# SITE PLAN FOR PROPOSED STORAGE UNIT DEVELOPMENT PARCEL NO-06-26-301-034 HOWELL TOWNSHIP, MI

**Site Plan Review  
For  
Howell Township, Michigan**

<b>Applicant:</b>	Tom Schroeder
<b>Project Name:</b>	Cornerstone Group
<b>Plan Date:</b>	June 20, 2024
<b>Location:</b>	East of W Highland Road (M-59) & North of I-96
<b>Zoning:</b>	Industrial (I)
<b>Action Requested:</b>	Preliminary Site Plan Approval

RE: Proposed Storage Unit Development (Transcontinental West)  
Parcel #06-26-301-034 Howell Township  
Preliminary Site Plan Review

- C-1 COVER SHEET
- C-2 EXISTING CONDITIONS
- C-3 PROPOSED SITE PLAN
- C-4 DIMENSION PLAN
- C-5 DETAILS SHEET
- LP-1 LANDSCAPE PLANTING PLAN
- LP-2 LANDSCAPE NOTE AND DETAILS
- PHOTOMETRIC SITE PLAN

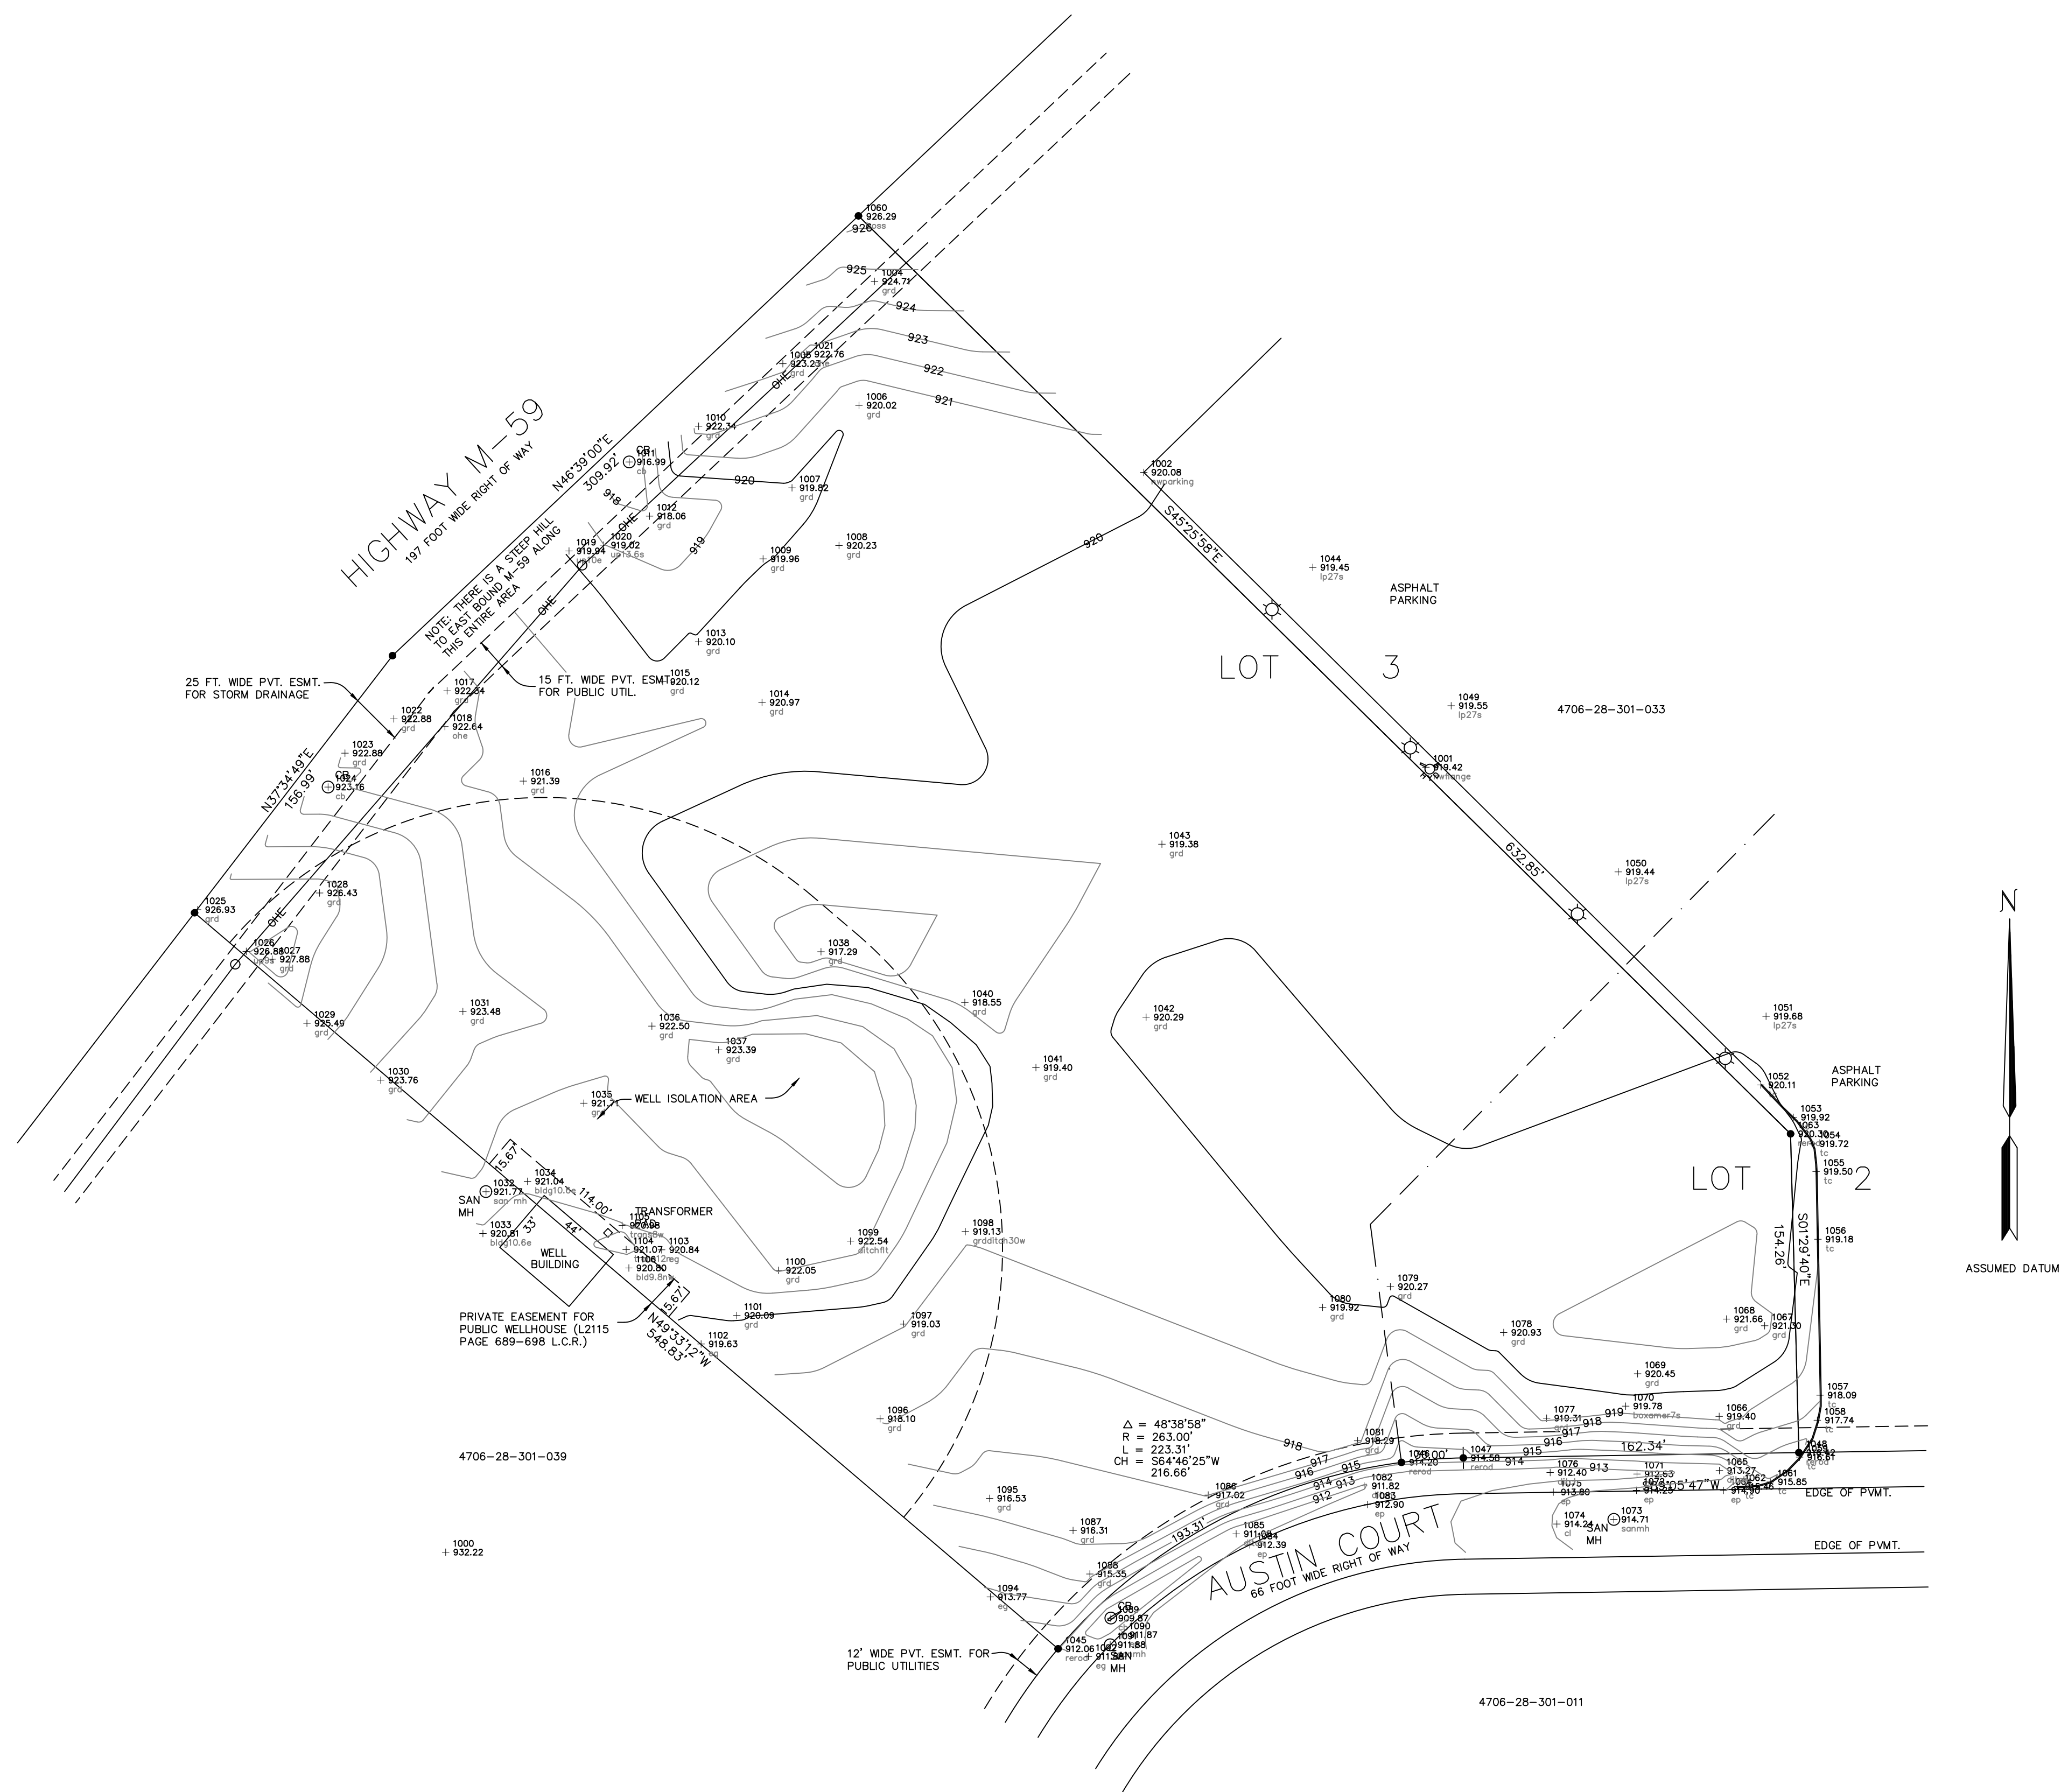
**Items to be Addressed:** 1) The applicant to clarify the intended use of the site and functionality on the plans. 2) Sheet C-1 shall be edited to list the correct parcel ID (4706-28-301-034) for the site address and tax ID number.

The cover sheet includes a vicinity map. This map should include the following:

The cover sheet should have the seal of an Engineer licensed in the state of Michigan.

PROPOSED SITE PLAN  
 SCALE: 1"=40'

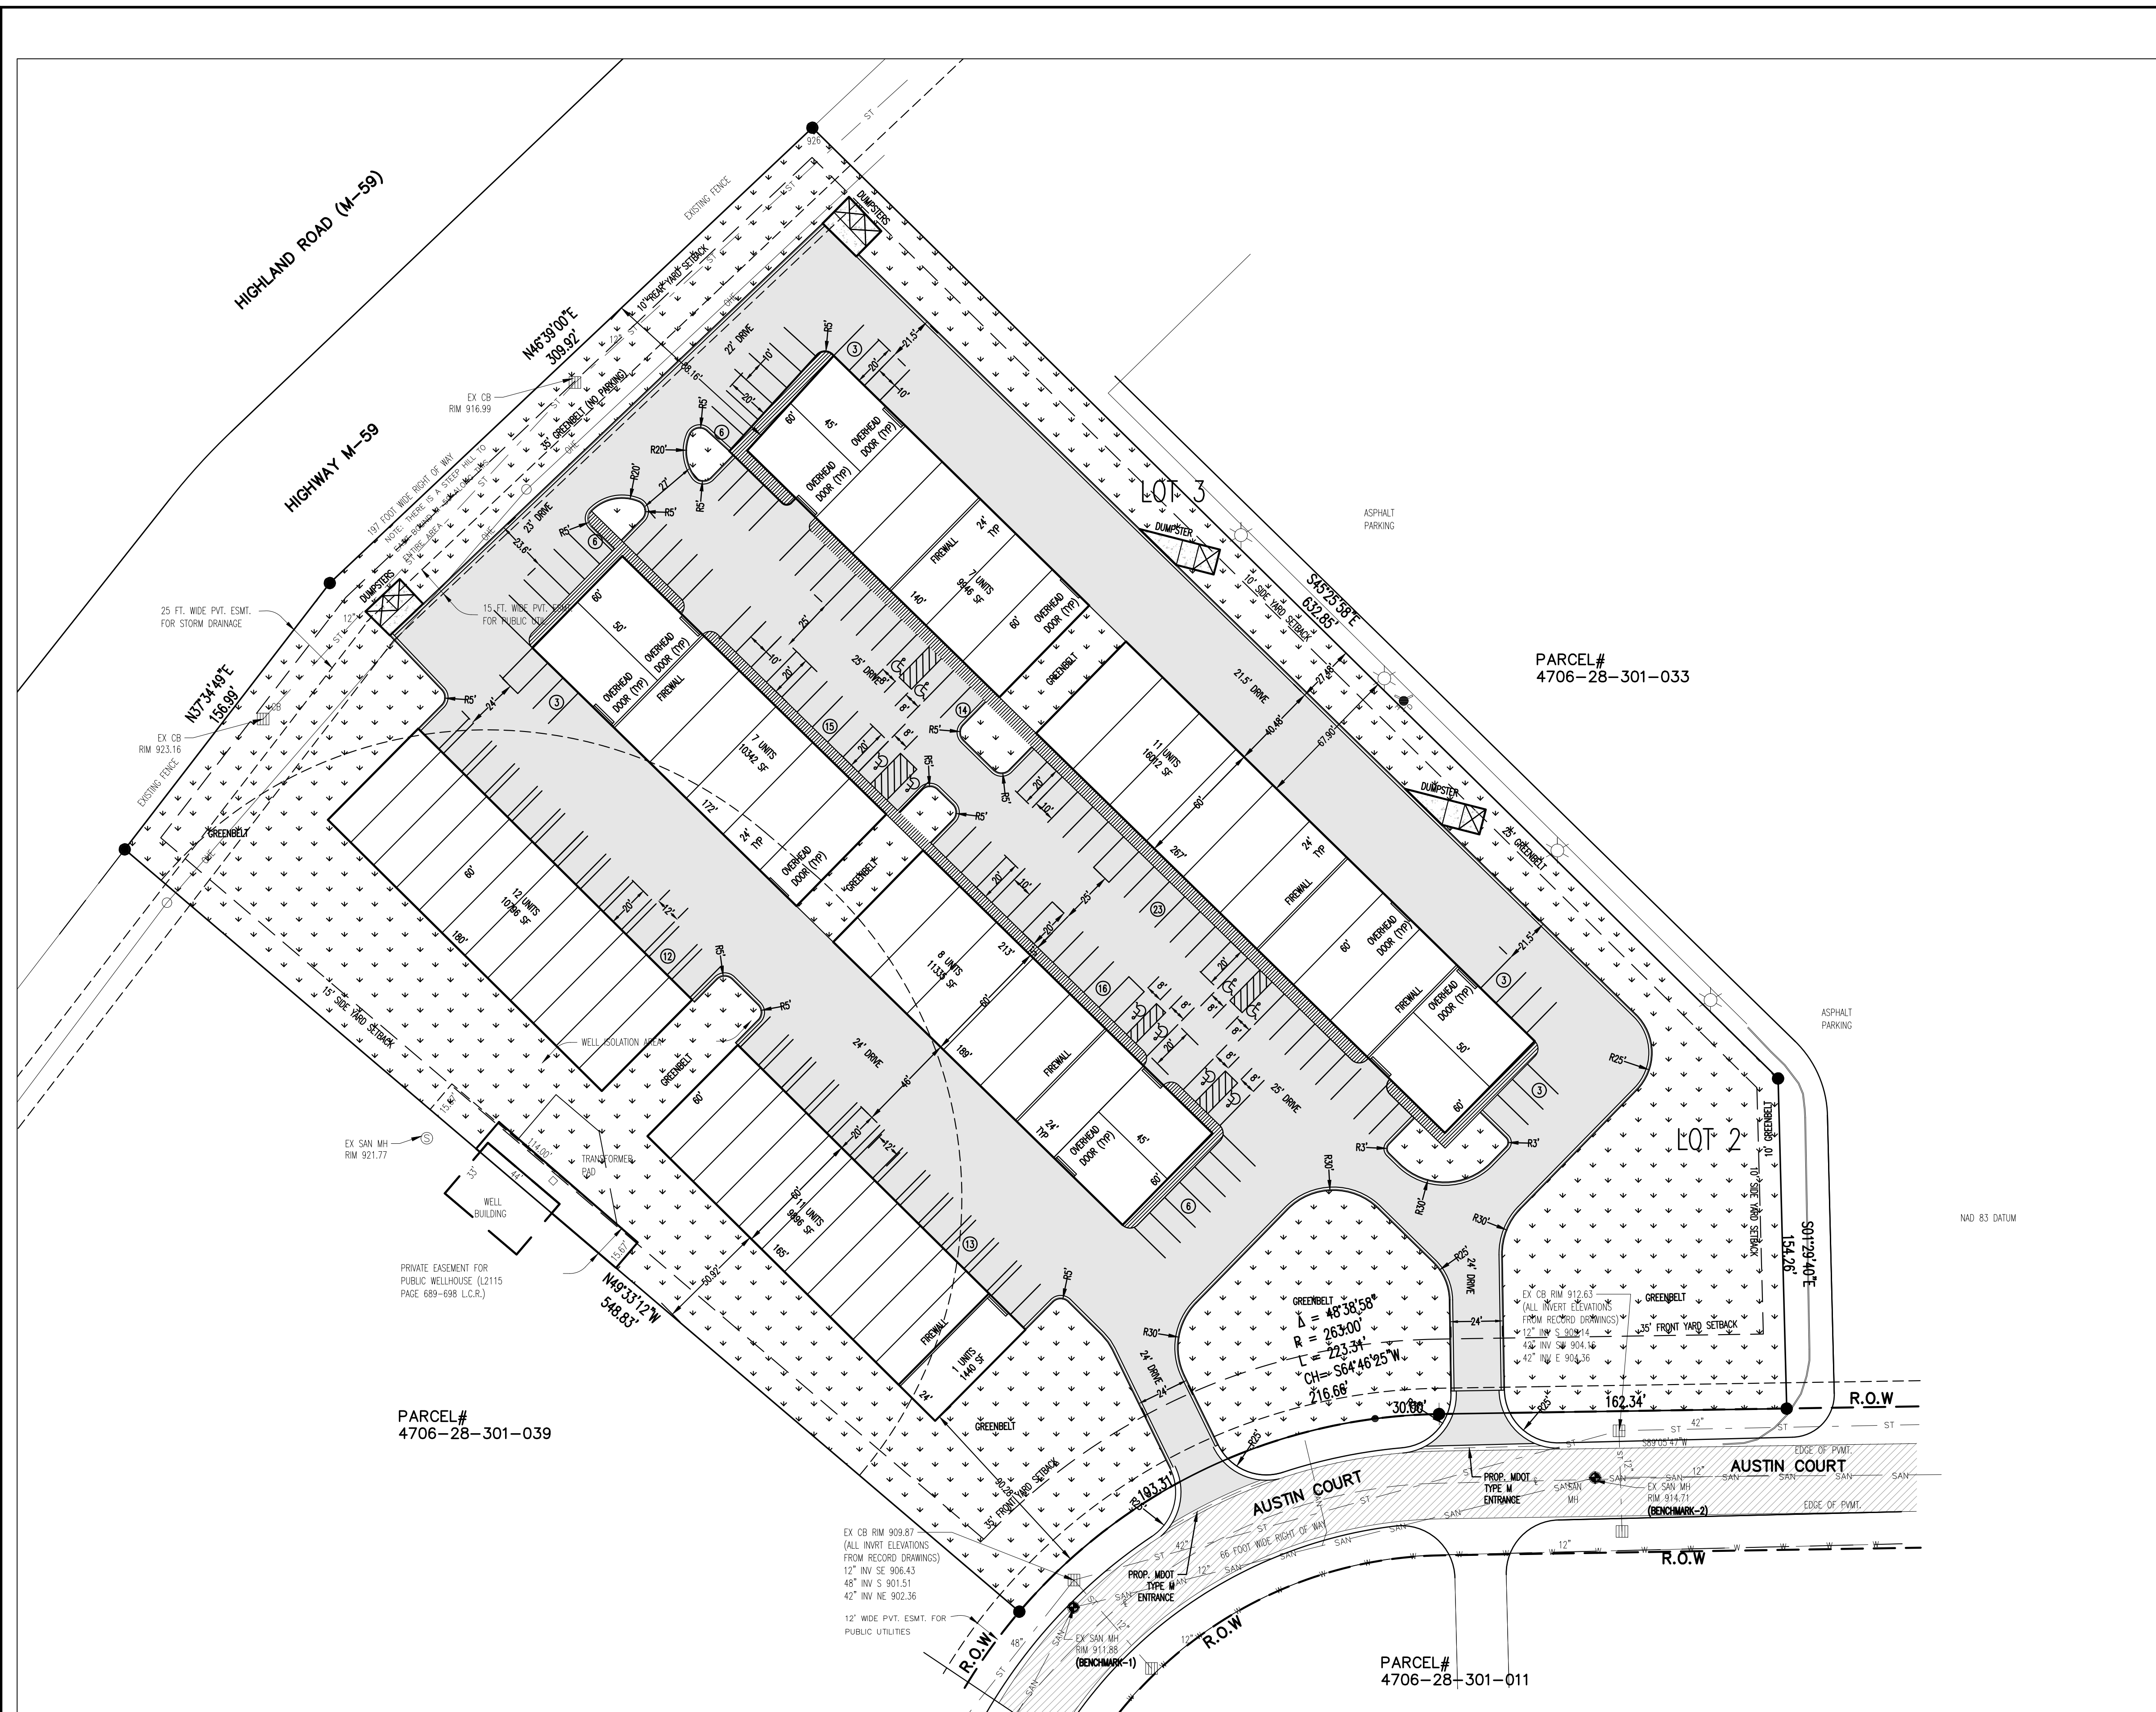
*Items to be Addressed: Provide building height for proposed buildings.*

*Items to be Addressed: 1.) The applicant shall provide parking calculations for the proposed use to demonstrate compliance with Section 18.02G. of the Zoning Ordinance.*

**Items to be Addressed:** 1) *The ends of parking rows should have parking islands.* 2) *The applicant shall provide a circulation map with turning templates to demonstrate that trucks and fire apparatus can navigate the site.*

**Items to be Addressed:** 1) Provide trash enclosure details for the two (2) dumpsters along the eastern lot line. 2) Relocate trash receptacles along Eastern property line to avoid encroachment on the ten (10) foot side yard setback.

Setback requirements are correctly listed on the plan with the exception of the rear yard set back which is listed as 10'. Section 26.05 of the Howell Township Zoning Ordinance states that the setback requirement along M-59 is minimally 50-feet from all buildings and 20-feet for all other structures. There does not appear to be a conflict, the building has approximately 90 feet of clearance and the dumpster has 21 feet of clearance. There are 2 dumpsters encroaching on the side yard setback to the northeast.

The height of the proposed buildings should be included on the plans
